Town of Kittery Planning Board Meeting February 9, 2023

ITEM 4 – 35 Badgers Island West, Site Plan and Shoreland Development Plan

**Re: Sketch Plan Application; Amended Site Plan – Conversion to Residential
Tax Map 1, Lot 32, 35 Badgers Island West**

SHORELAND DEVELOPMENT PLAN

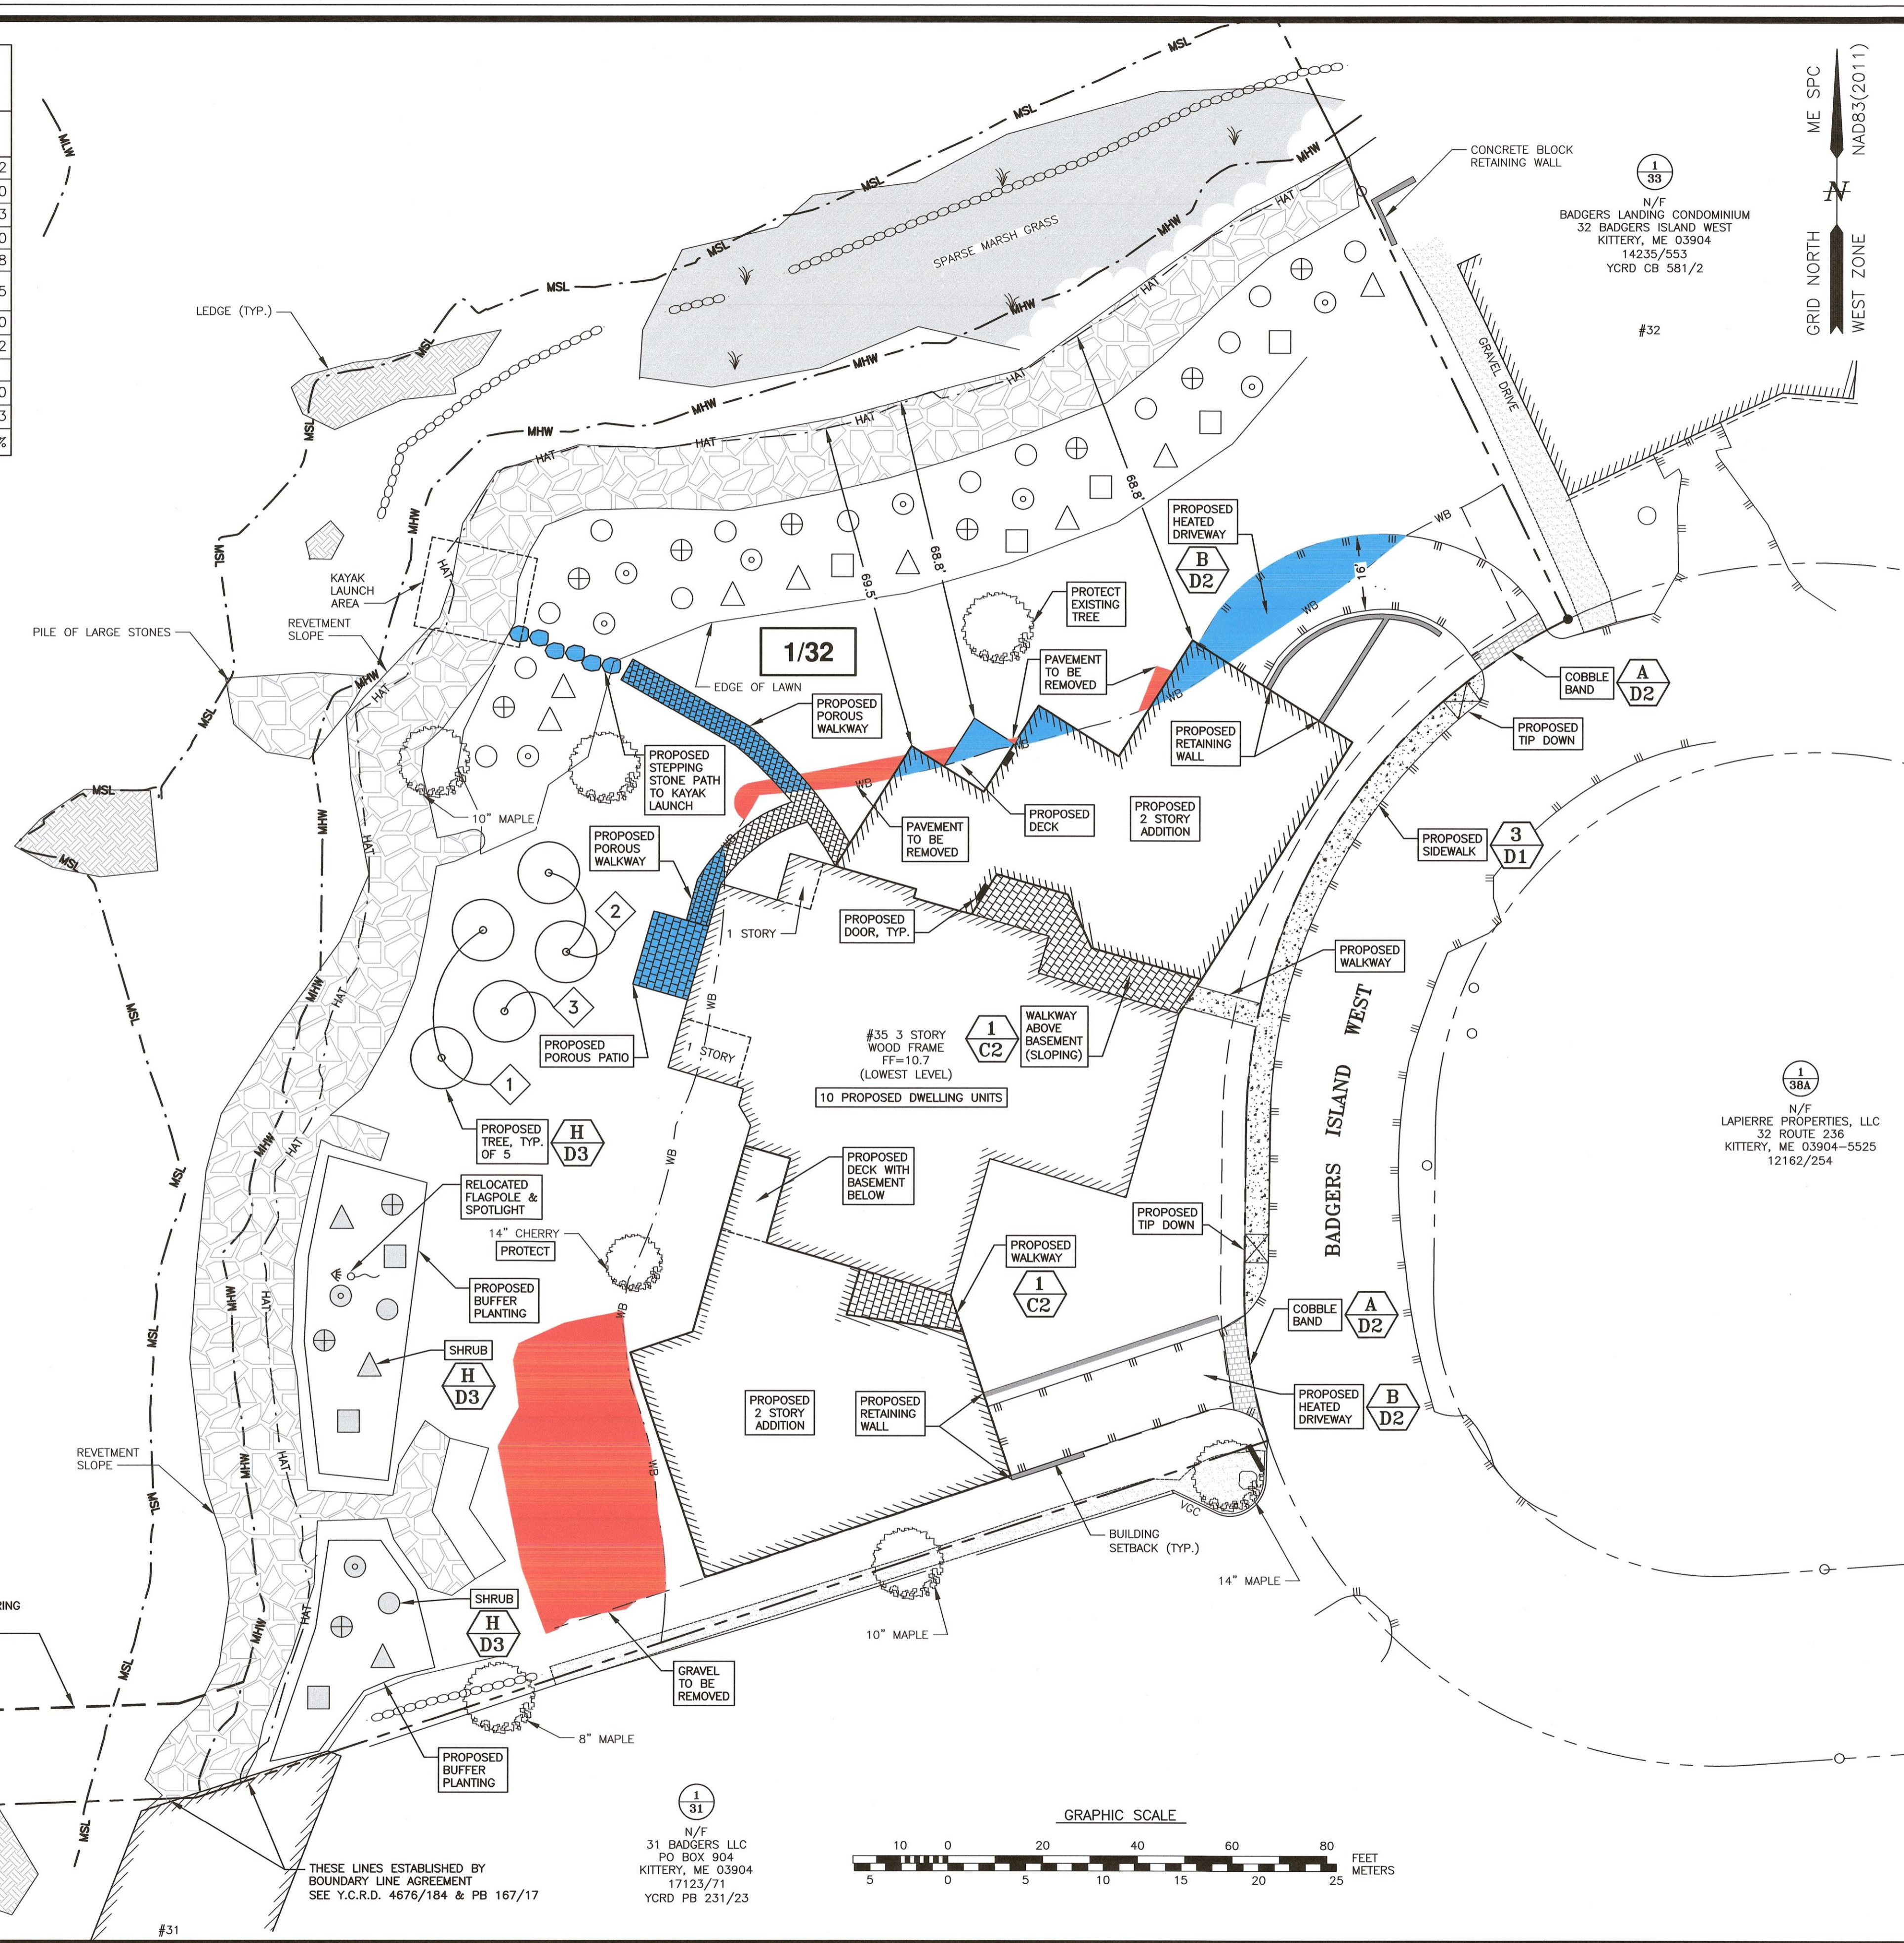
81 *The devegetation table on Sheet C2 shows the land area is 54,883 – perhaps that is calculated*
82 *based on the definition above but the plans should be consistent in all cases with Title 16’s*
83 *requirements.*

114 *The devegetation table shows that 41.2% of the lot as proposed will be developed which leaves 58.8%*
115 *as “green” but the Applicant indicate in a plan note that the open space standard is being met.*
